DEVIATION REQUEST AND DECISION FORM

Project Name :	Winsome Filing No 1
Schedule No.(s) :	Existing Right of Way
Legal Description :	Same

A deviation from the standards of or in **Section 2.3.5** of the Engineering Criteria Manual (ECM) is requested.

TYPICAL SECTIONS

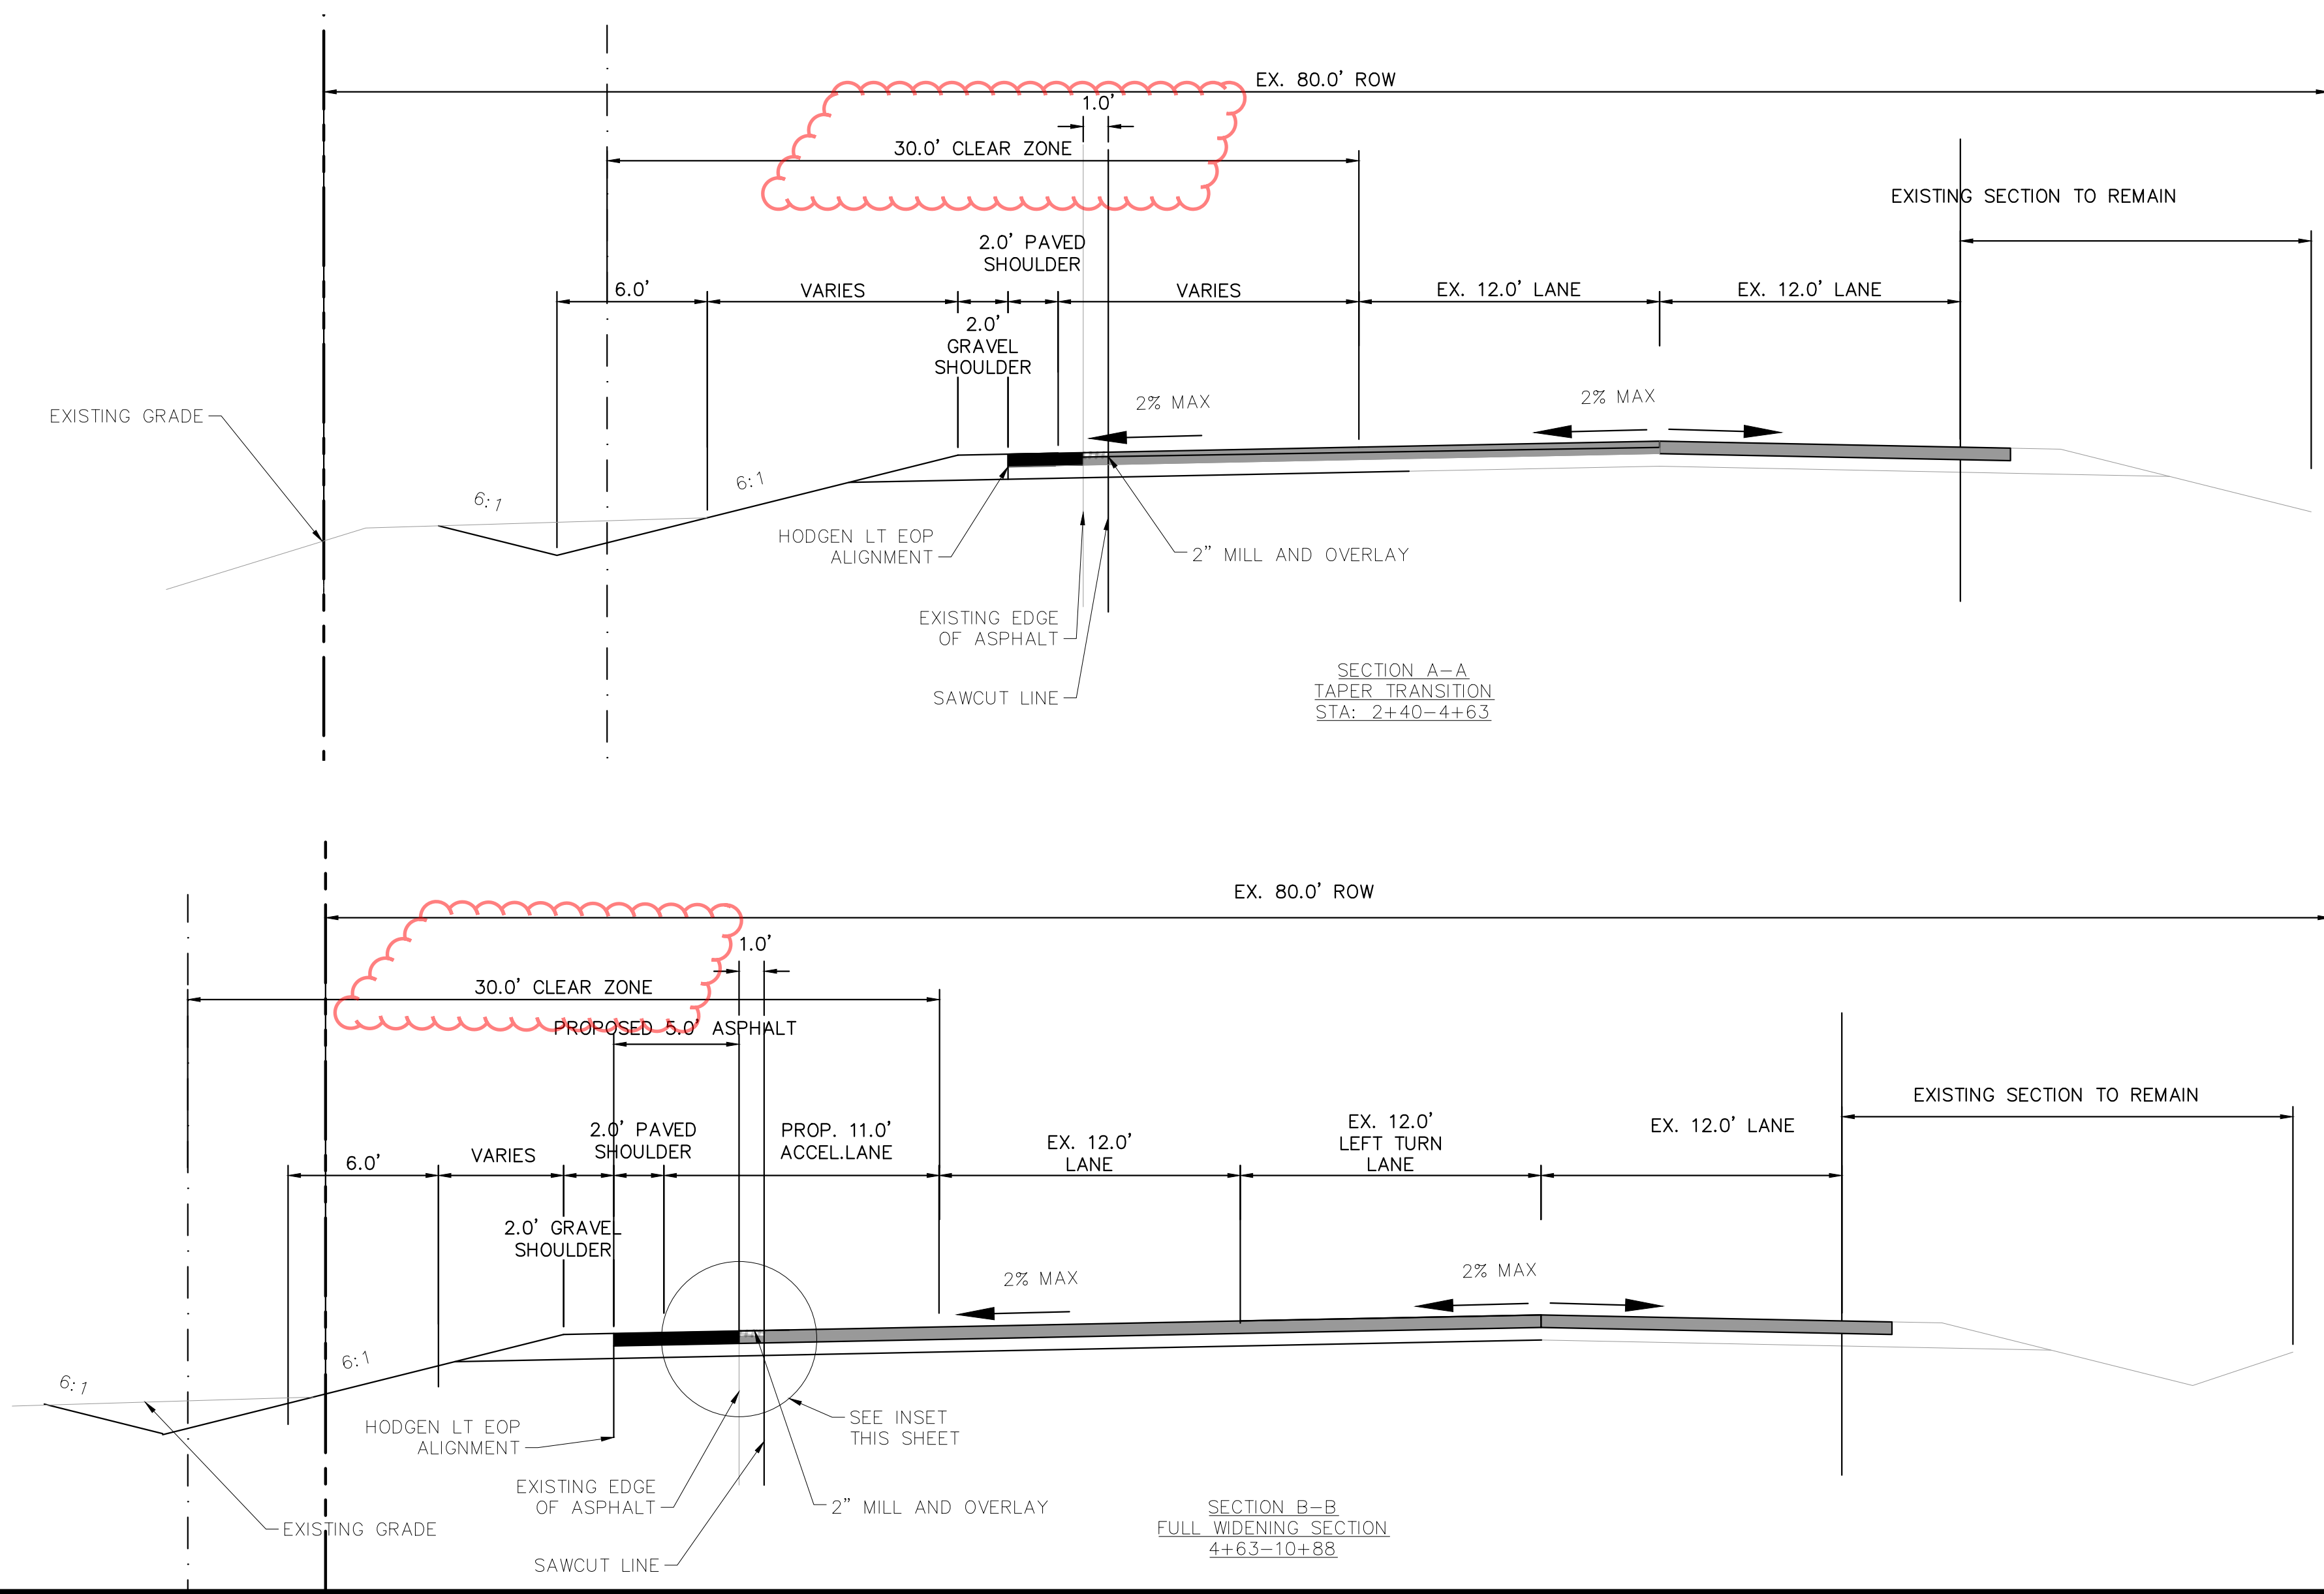
- Table 2-4 Roadway Design Standards for Rural Minor Arterials specifies a clear zone of 30'
- Approximately 4 overhead power poles exist north of Hodgen Road and west of Winsome Way and one utility pedestal east of Winsome Way within the clear zone. [Please see attached exhibit showing clear zone and obstacles.](#)

- The proposed alternative is to allow the overhead power poles and utility pedestal to exist in the clear zone. This is an existing condition. Other alternatives such as guardrail, would provide greater obstruction and less opportunity for recovery. [Applicant will inform the communications company that their pedestal is not allowed in the public right-of-way.](#)
[We will recommend they relocate their facilities to be near the north end of the 40' preservation easement.](#)
